COLLAGE
PARCEL 2, PROVIDENCE

U R B A N I C A

Responses on financials/programs:

Responses on Design comments:

Design: View of Gateway on South Main St.

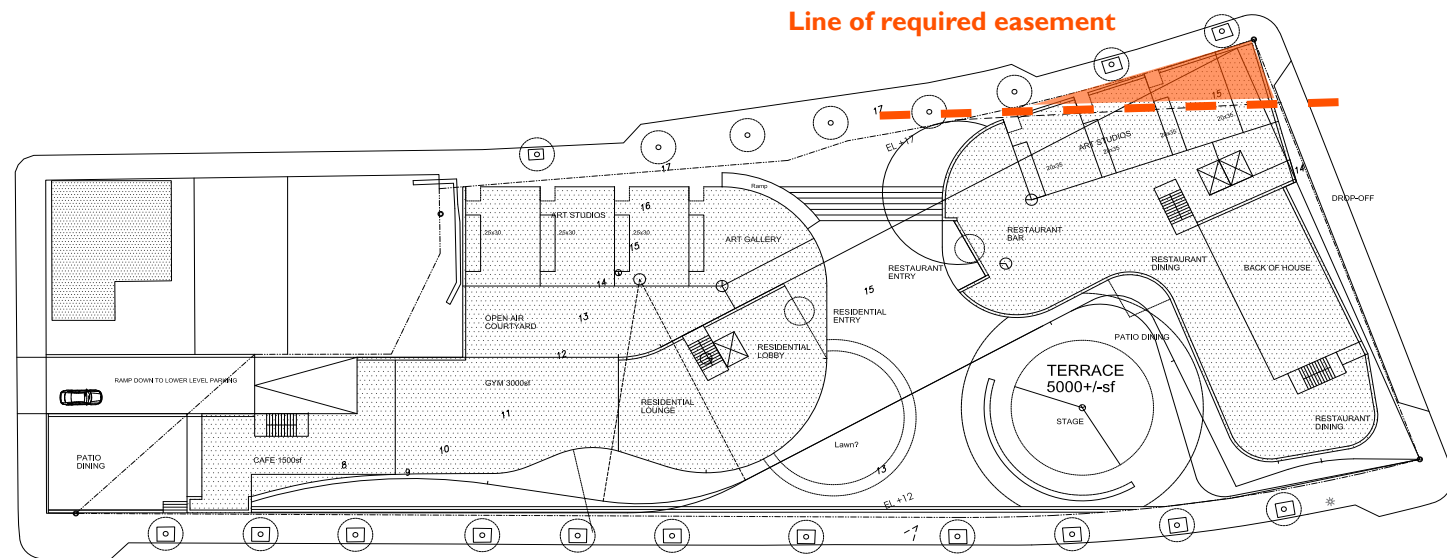
1. From S.Water St, the scheme builds continuously as one block, reads as monolithic compared to its immediate building context
2. Exterior material: consider the color and material of the main building that fits the context better and better conceived.
3. Consider reduce the scale of the building, and depth.
4. Dollar St should have more pedestrian activity at ground level

MATERIALITY-

Note that the curved areas are actually "faceted" i.e. made up of straight segments which are progressively "stacked" to give the impression of continuous curves.

ORIGINAL
GROUND FLOOR PLAN

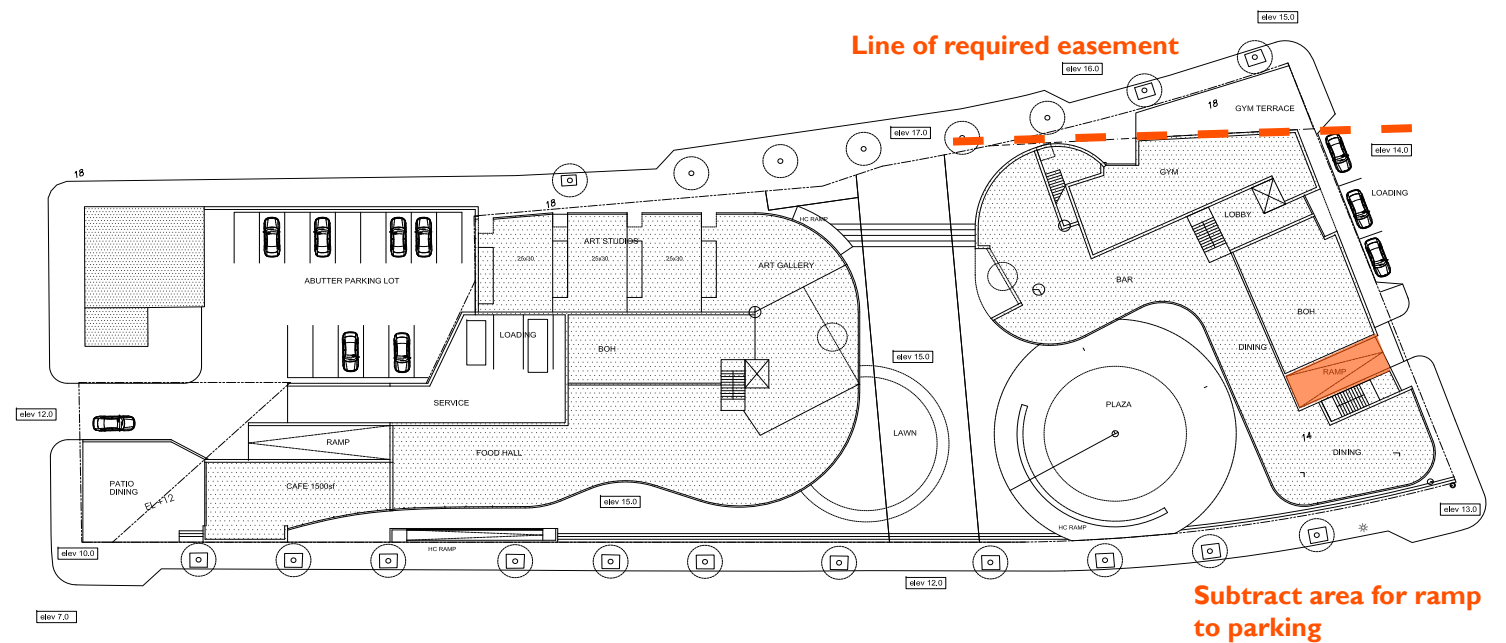
3. -REDUCE SCALE and DEPTH

The updated design has reduced the square footage by about 10%.

- a) The original design mistakenly ignored an easement at the corner of S Main St and Dollar St.
- b) The parking level required a second ramp- which also leads to a decrease in Square footage.

ORIGINAL
UPPER FLOOR PLAN

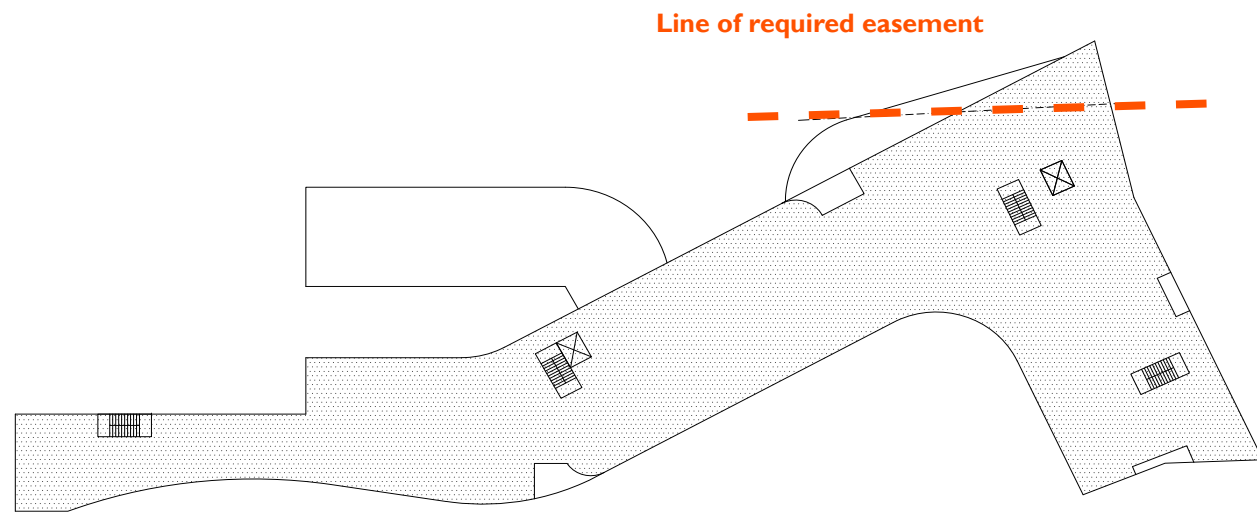
3. -REDUCE SCALE and DEPTH

The updated design has reduced the square footage by about 10%.

- a) The original design mistakenly ignored an easement at the corner of S Main St and Dollar St. This has been remedied on all floors.
- b) The upper floors have been set back on Dollar Street to reduce the scale of the building- especially from eye level.
- c) The number of indentations have been increased and also enlarged to further reduce the sense of scale of the building.
